ADDENDUM NO. 02

COLTON MIDDLE SCHOOL – INTERIM HOUSING

DSA #04-124403

RCA Project No. 1-15-118

ENLARGED SITE PLAN - PARKING LOT MOD SCALE: 1/8" = 1'-0" 9

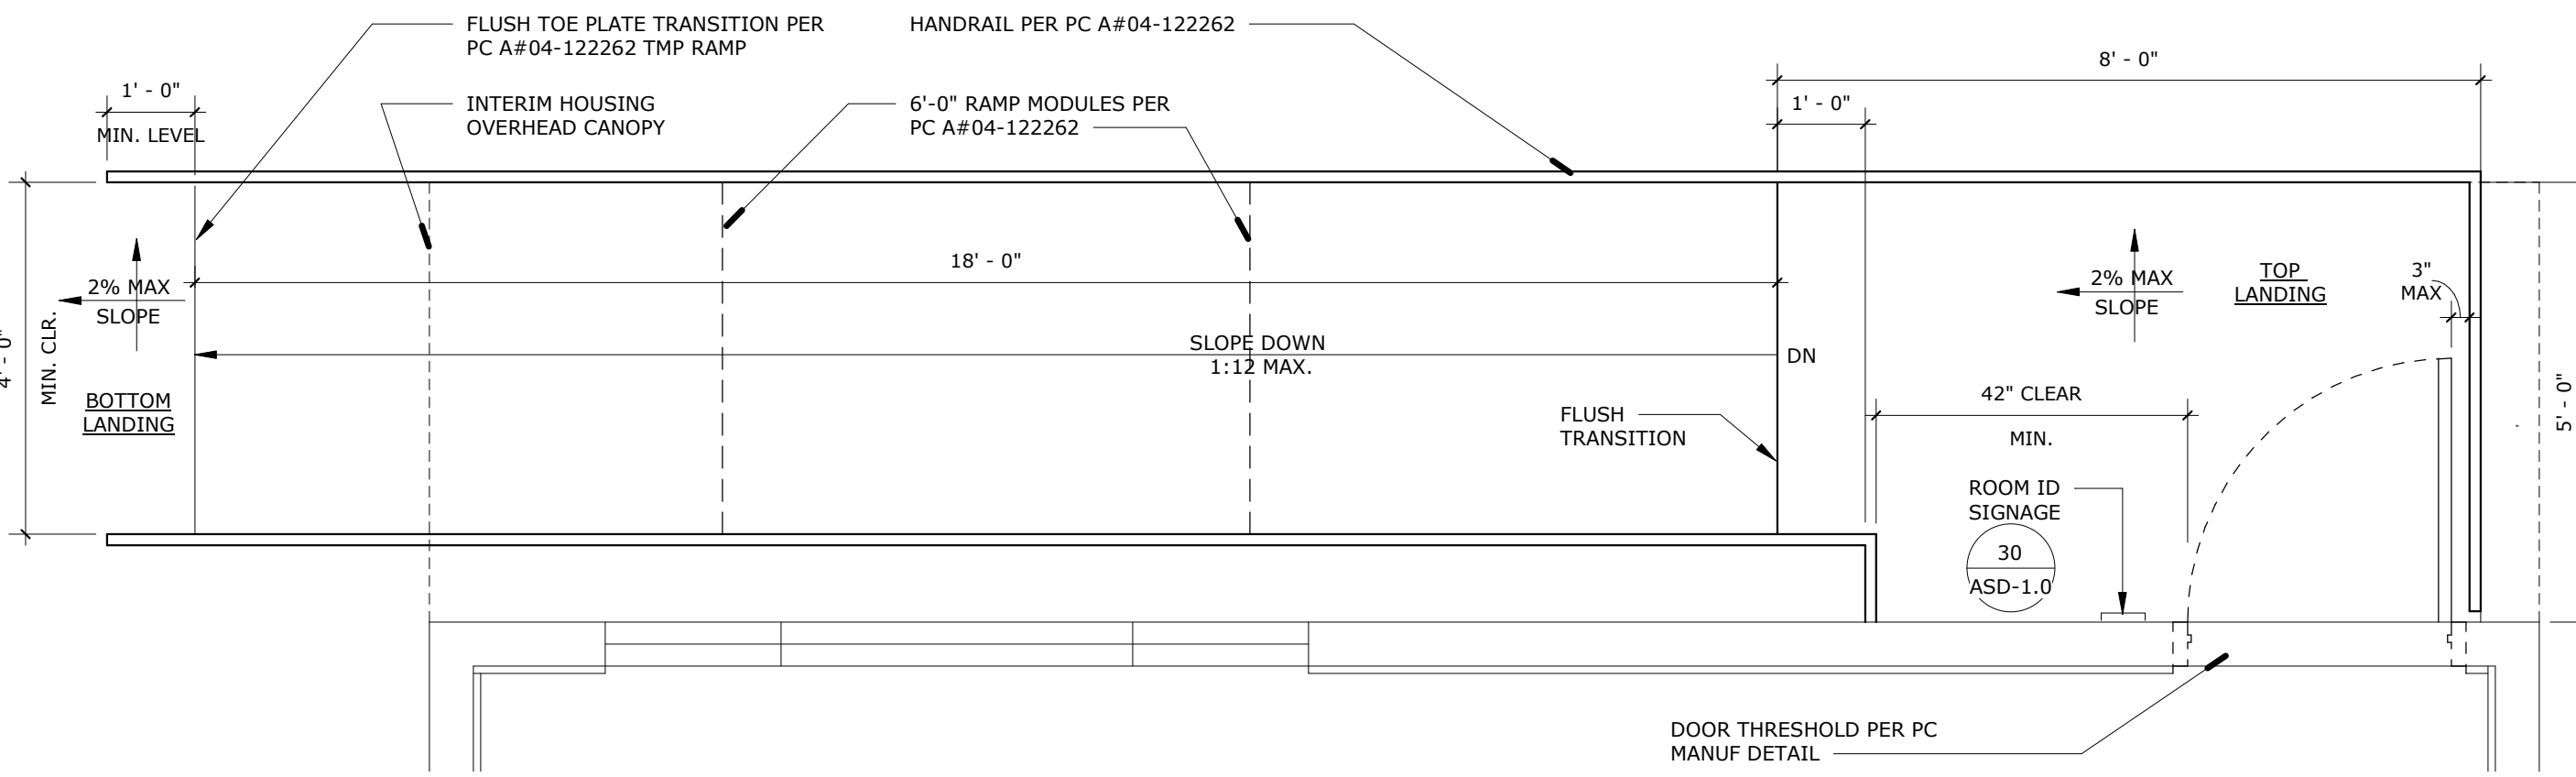
- Item No 2.1 Reference Sheet G-1 – Title Sheet & Sheet Index
 - 2.1.1 Removed sheet F3.01 and F3.11 from to Modtech drawings
 - 2.1.2 Added sheets F1.02 and F1.21 from Modtech drawings
 - 2.1.3 Revised Scope of Work narrative to show portable units N and P as OFOI.
- Item No 2.2 Reference Sheet AS-1.0 – Fire Access Site Plan
 - 2.2.1 Revised restroom at Portable P to match Silvercreek Modular drawings
- Item No 2.3 Reference Sheet AS-1.1 – Overall Site Plan & Code Analysis
 - 2.3.1 Revised restroom at Portable P to match Silvercreek Modular drawings
- Item No 2.4 Reference Sheet AS-1.3 – Enlarged Site Plan at Parking Lot Mod
 - 2.4.1 Revised restroom at Portable P to match Silvercreek Modular drawings
 - 2.4.2 Revised keynote 32.33.16.1 ramp to OFOI
- Item No. 2.5 Reference Sheet E-0.2 – Electrical Schedules

ELECTRICAL
SCHEDULES

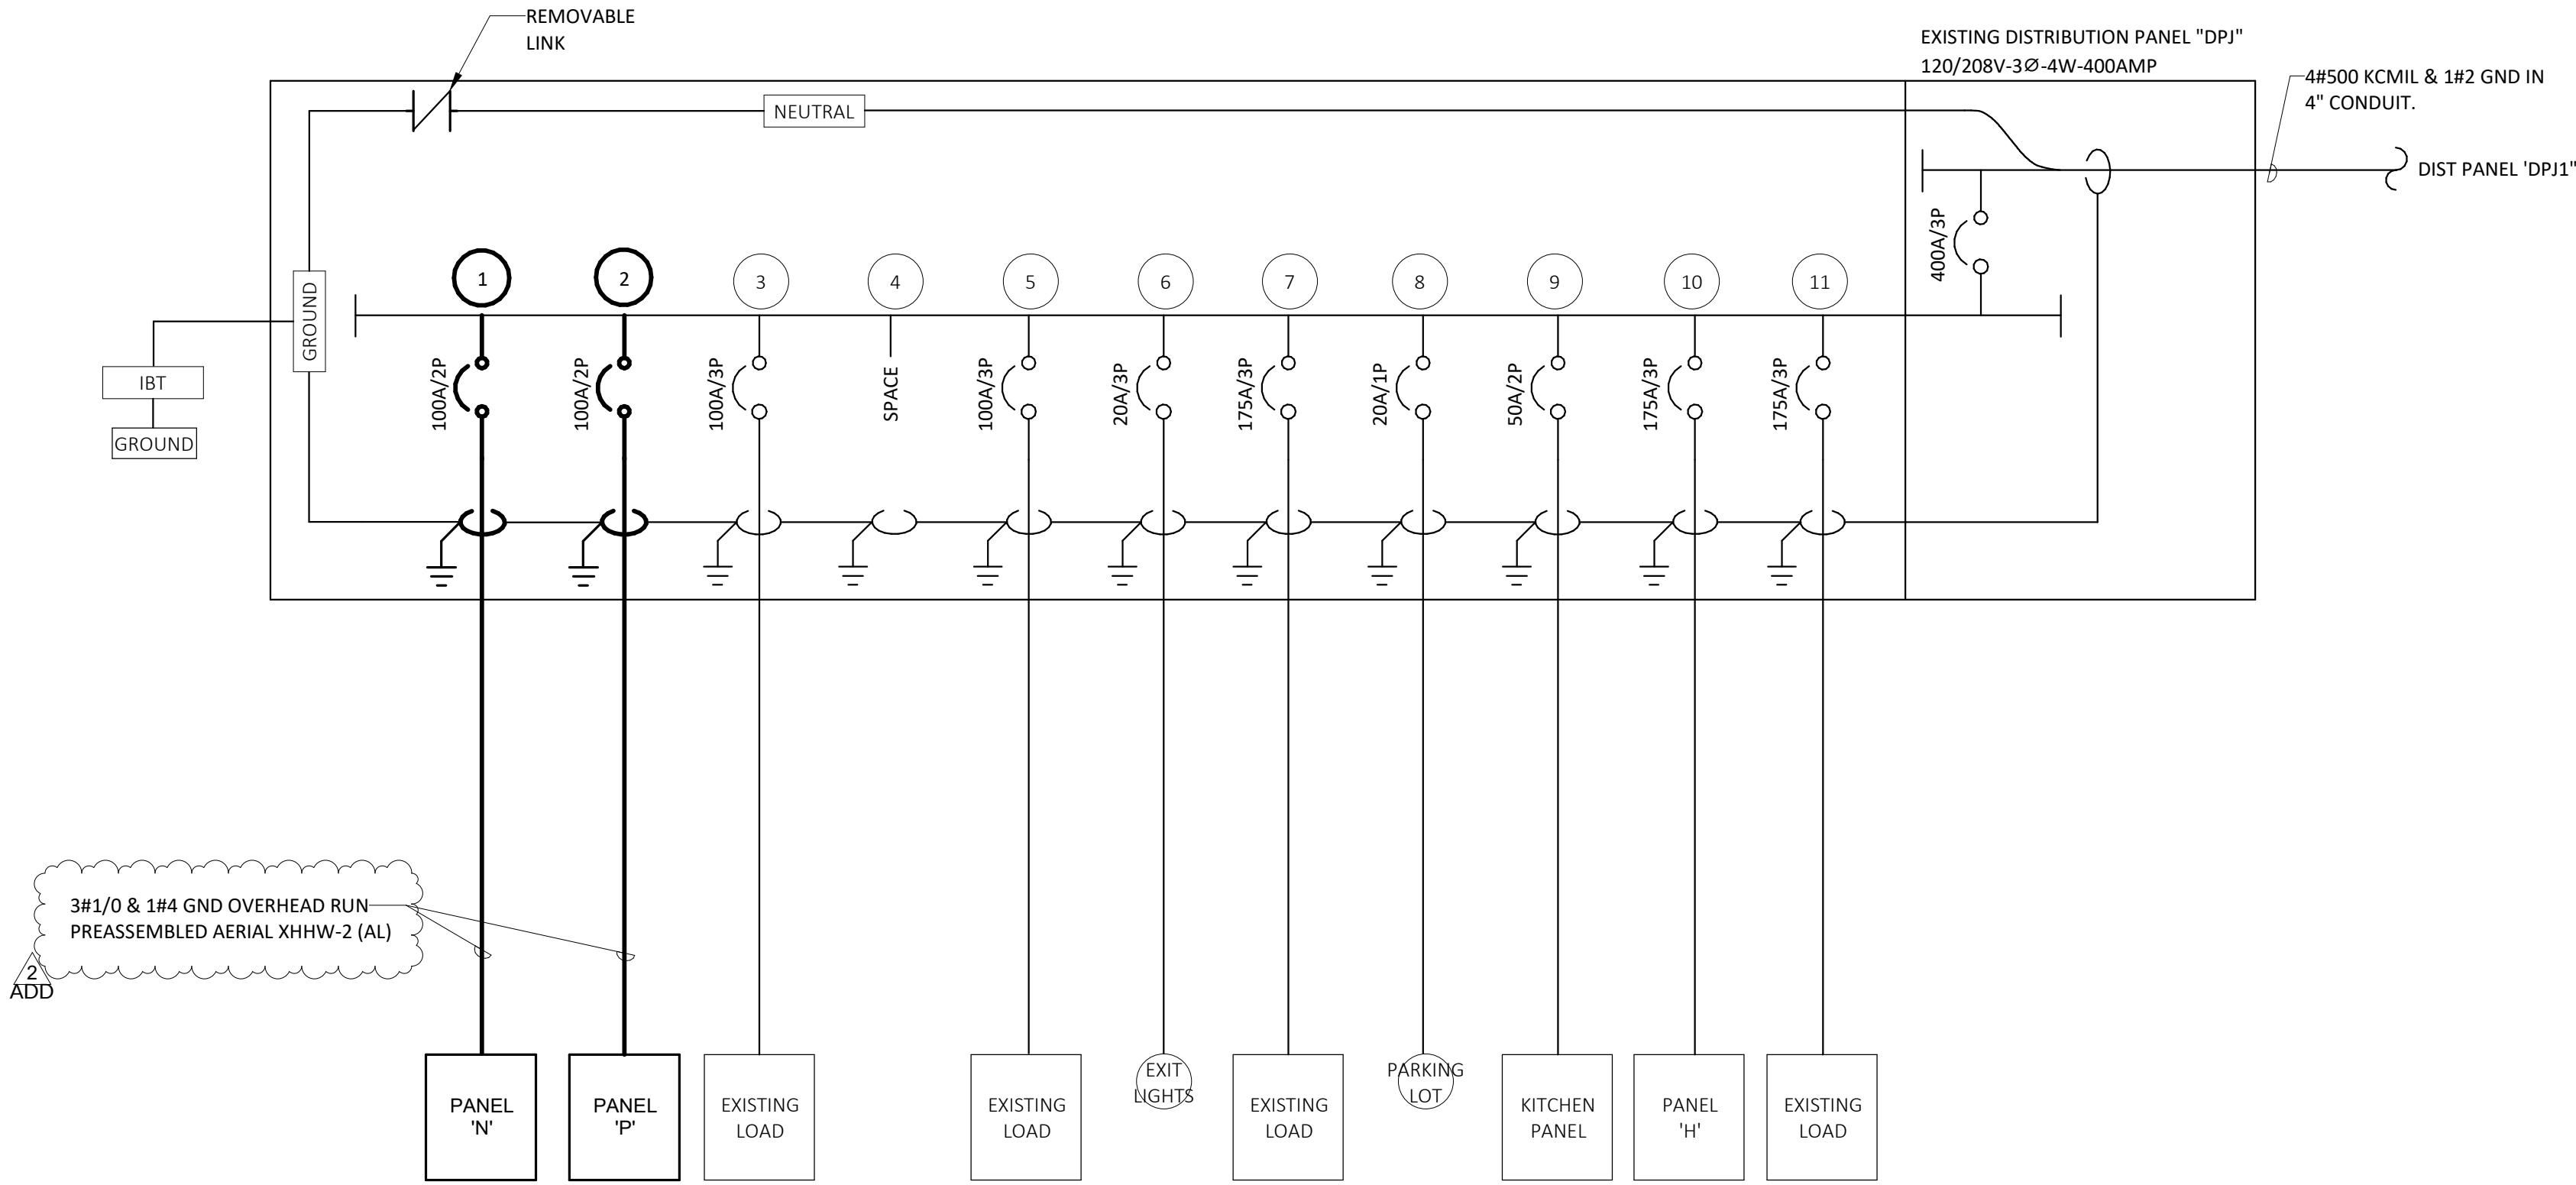
- 2.5.1 Revise per clouded areas of attached sheet and items listed below
a) Revised wire size and quantity for panel feeders to modular buildings.
- Item No. 2.6 Reference Sheet ES-1.1 – Electrical – Enlarged Site Parking Lot

1 ELECTRICAL - ENLARGED SITE PARKING LOT
1/8" = 1'-0"

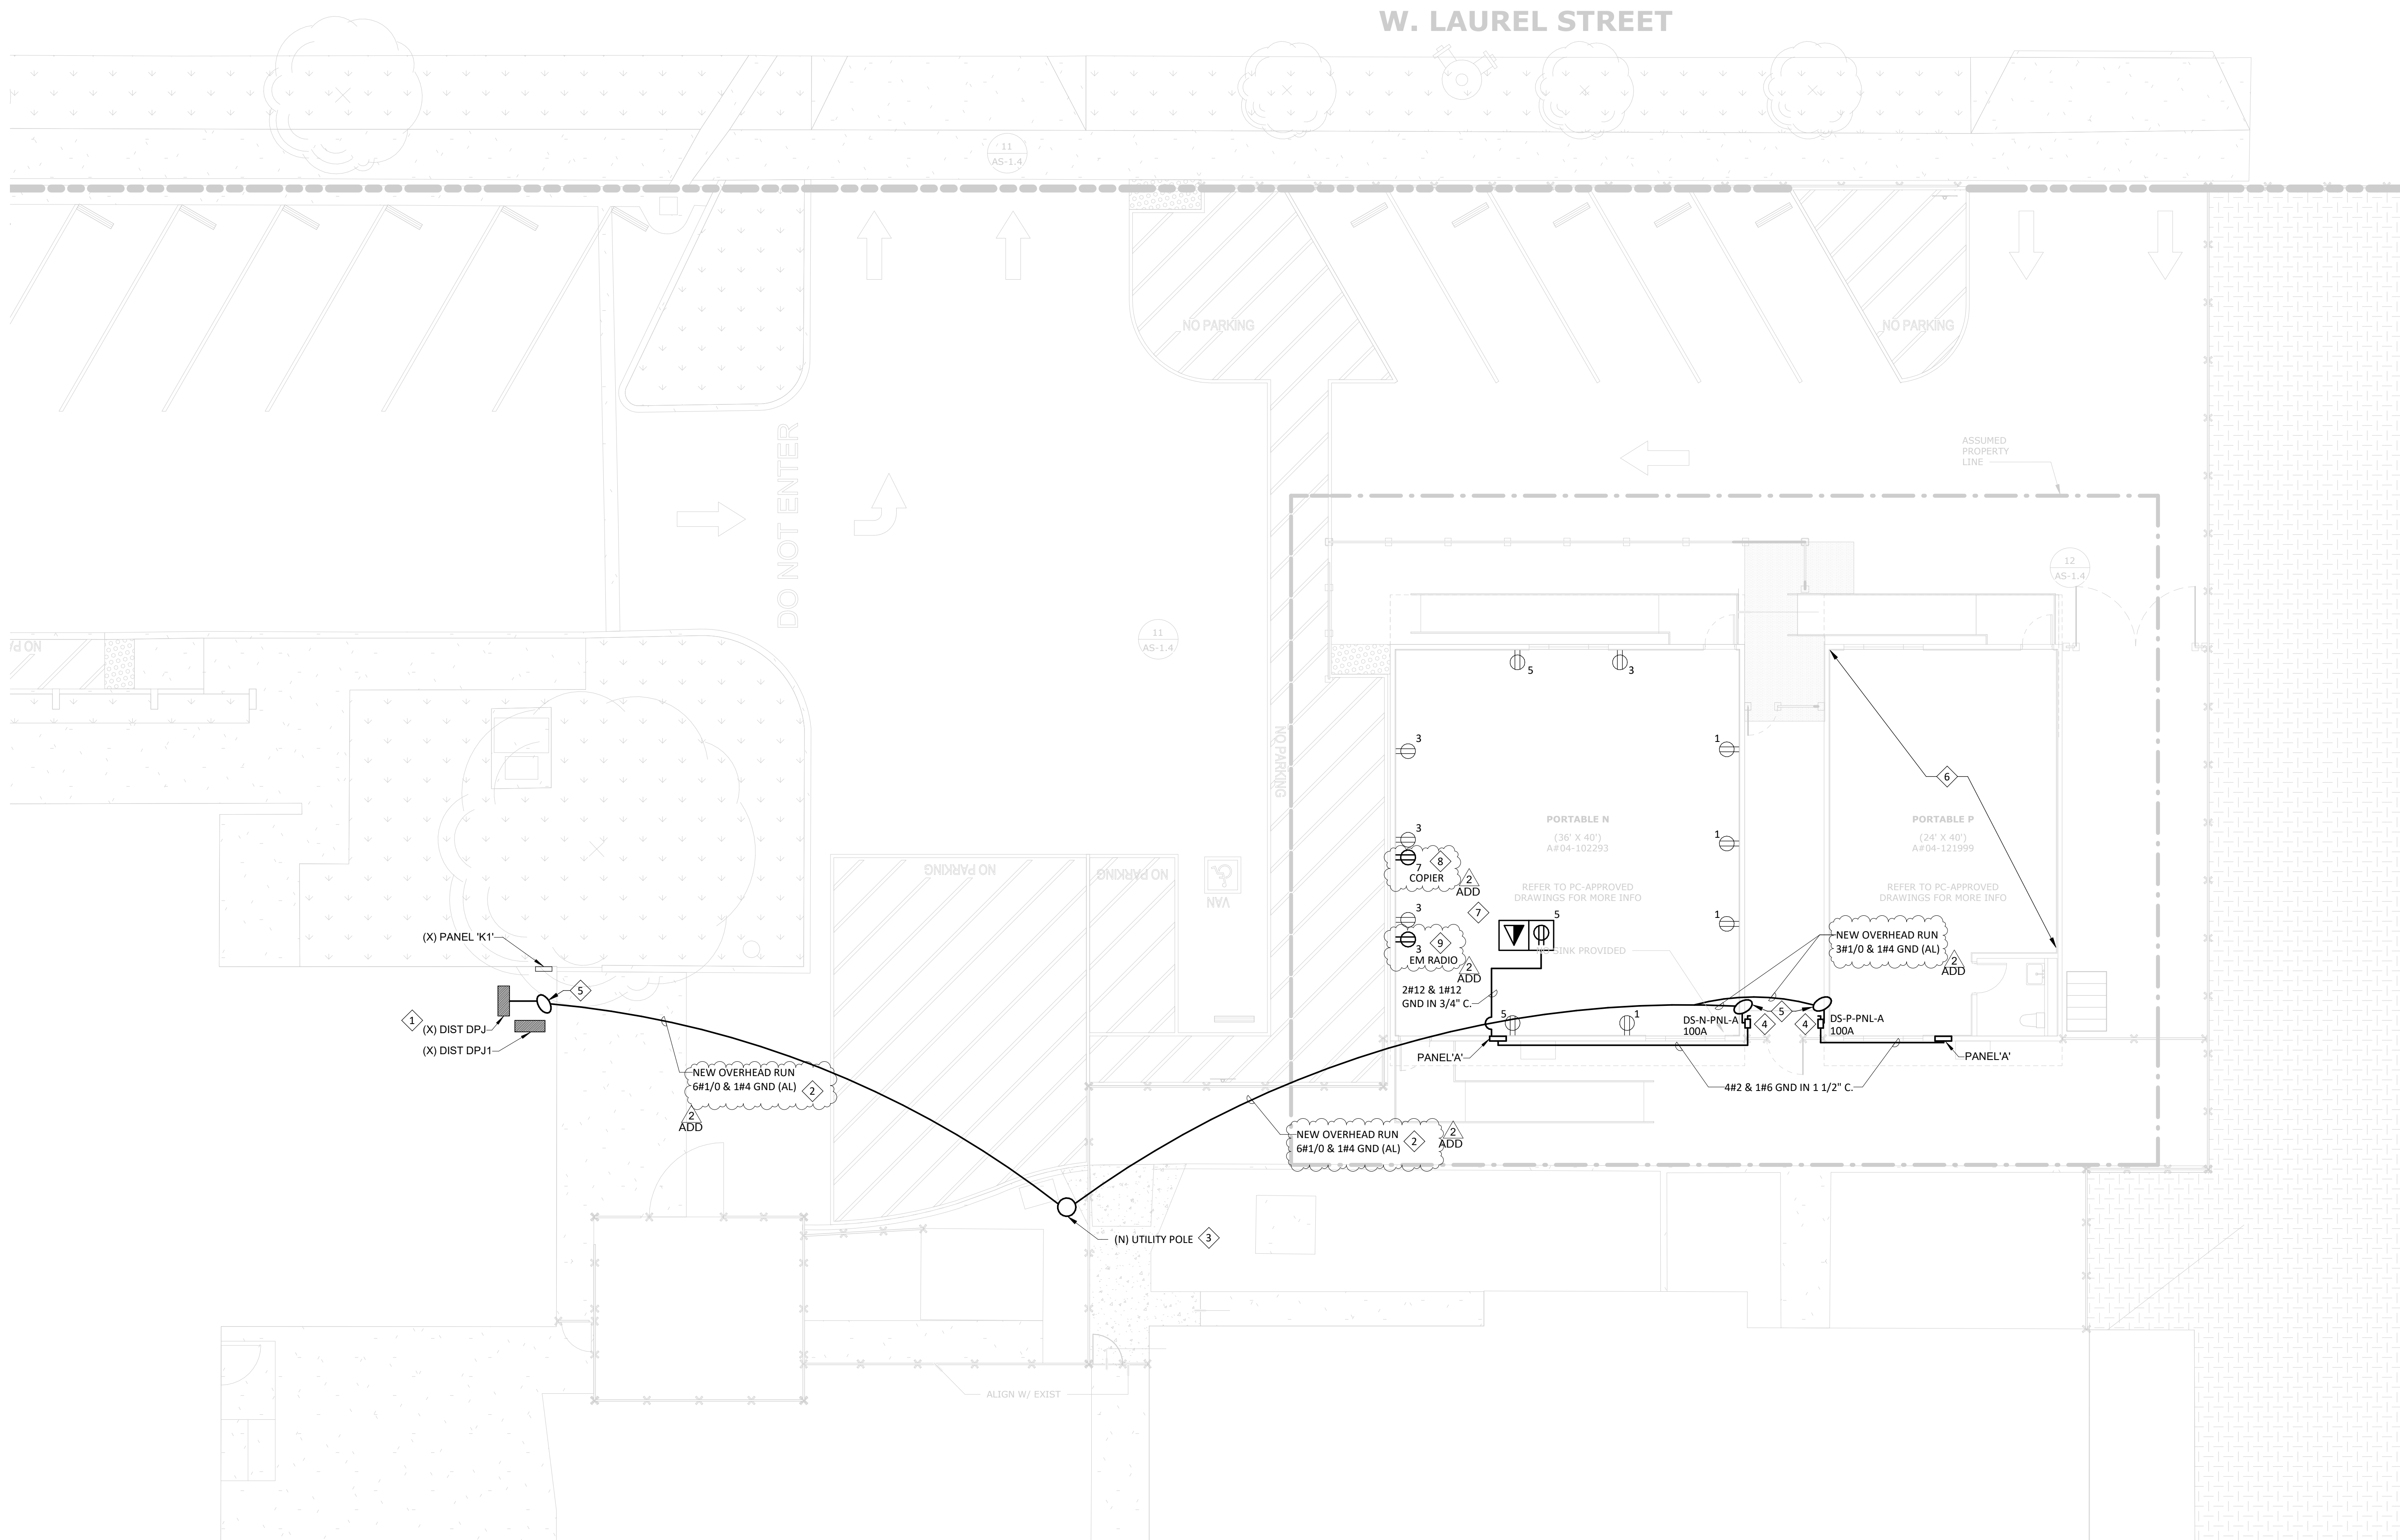
2.6.1 Revise per clouded areas of attached sheet and items listed below
a) Revised Keynotes 3 and 7.
b) Added Keynotes 8 and 9.
c) Updated wire sizes and quantities for aerial conductors.

d) Added duplex receptacle for copier.
e) Added duplex receptacle for emergency radios.
- Item No. 2.7 Reference Sheet T-0.1 – Technology Cover Sheet
2.471 Revise per clouded areas of attached sheet and items listed below

KEYNOTES - ES-1.1	
NUMBER	TEXT
1	UTILIZE EXISTING DISTRIBUTION BOARD 'DPJ' TO FEED NEW MODULAR BUILDINGS.
2	PROVIDE OVERHEAD RUN TO UTILITY POLE. SEE 1/E-4.0 FOR CABLE RUN RESTRICTIONS.
3	PROVIDE NEW UTILITY POLE AND GUY WIRE. SEE 1/E-4.0 FOR POLE INSTALLATION.
4	PROVIDE POINT OF CONNECTION TO PORTABLE BUILDING. SEE 2/E-4.0 FOR DISCONNECT SWITCH INSTALLATION.
5	PROVIDE WEATHERHEAD AND RISER PIPE FOR ELECTRICAL FEEDER CONNECTION OF OVERHEAD RUN. PROVIDE SEPARATE WEATHERHEAD AND RISER PIPE FOR OVERHEAD RUN OF FIRE ALARM AND TECHNOLOGY CABLEING.
6	PORTABLE 'P' ELECTRICAL DESIGN TO BE PROVIDED BY SILVER CREEK. SEE PORTABLE MANUFACTURER PLANS FOR LAYOUT.
7	PROVIDE FLUSH FLOOR BOX TO ISLAND DESK USING UNDERFLOOR CONDUIT. UTILIZE BRANCH CIRCUIT IN PANEL 'A' TO FEED RECEPTACLE. 2#12 & 1#12 GND IN 3/4" C.
8	PROVIDE NEW DUPLEX RECEPTACLE FOR COPIER ON DEDICATED CIRCUIT. UTILIZE BRANCH CIRCUIT IN PANEL 'A' TO FEED RECEPTACLE. 2#12 & 1#12 GND IN 3/4" C.

9	PROVIDE NEW DUPLEX RECEPTACLE FOR EM RADIO ON EXISTING RECEPTACLE CIRCUIT. UTILIZE BRANCH CIRCUIT IN PANEL 'A' TO FEED RECEPTACLE. 2#12 & 1#12 GND IN 3/4" C.
